Alert Service Bulletin

Alert Service Bulletin No. 213

Turbocharger Turbine Housing Bolt P/N 400132-0301 Inspection

Figure-1 - Nonconforming Bolt

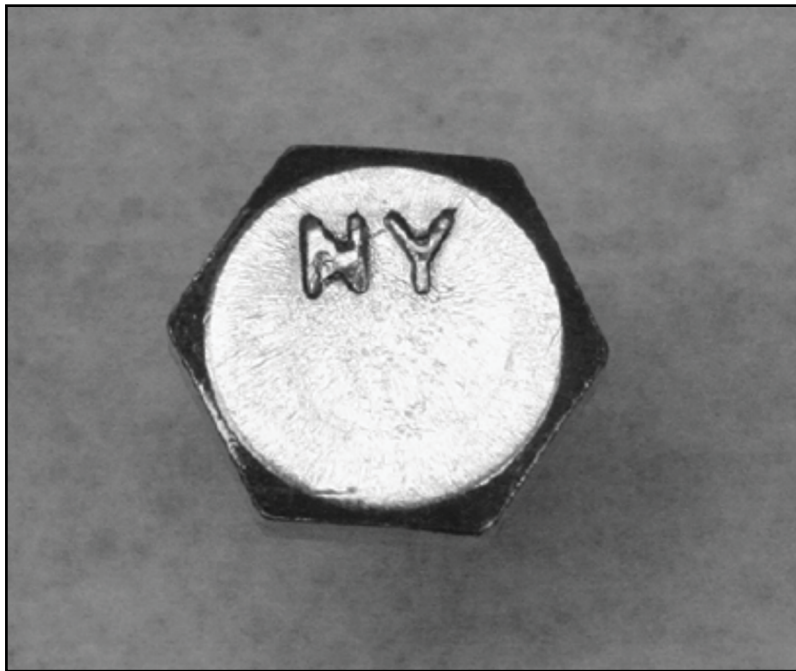
- (1) Gain access to the turbocharger in accordance with the latest engine/airframe service instructions or maintenance manual.
- (2) Locate the six turbine housing bolts (1) and inspect the bolts against Figure-1.
 - (a) A nonconforming bolt is labeled with the raised letters NY.
 - 1) If one or more of the six bolts **are** affected, continue to section 3.C., Corrective Action.
 - 2) If no bolts are affected, install any components that were removed to gain access in accordance with the latest engine/airframe service instructions or maintenance manual. Continue to 3.E., Maintenance Record.

Figure-2 - Bolt Pair and Lockplate Location - Typical

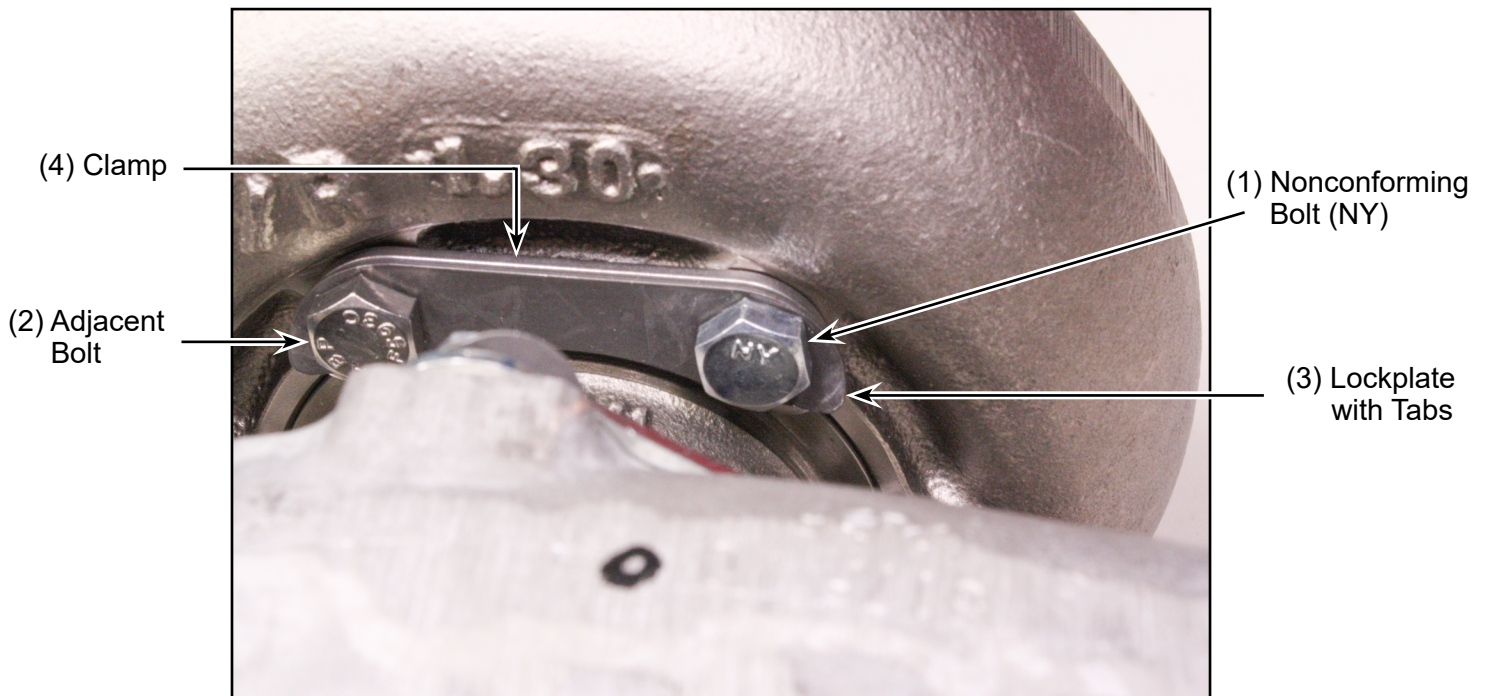
- (1) Replace the affected bolt (1), adjacent bolt (2), and lockplate (3) as a set. Refer to Section 2.A. Materials Required. See Figure-2 for illustration.

- (a) Bend lockplate (3) tabs down at location of affected bolt (1) and adjacent bolt (2).
- (b) Remove the affected bolt (1) and the adjacent bolt (2) securing the clamp (4) and lockplate (3). Discard the lockplate (3) and bolts (1 & 2).

- (c) Coat the threads of new bolts (1 & 2) with MRO Solution 2000 copper anti-seize (MRO Solutions L.L.C., Niles, IL. - previously Fel-Pro high-temperature compound C5A), or equivalent.
- (d) Install clamp (4), a new lockplate (3) and new bolts (1 & 2).

- (e) Torque new bolts (1 & 2) to 100-130 lbf-in (11.30-14.69 Nm).
- (f) Bend lockplate tabs up at new bolt (1 & 2) locations. Continue to 3.D, Return to Service.
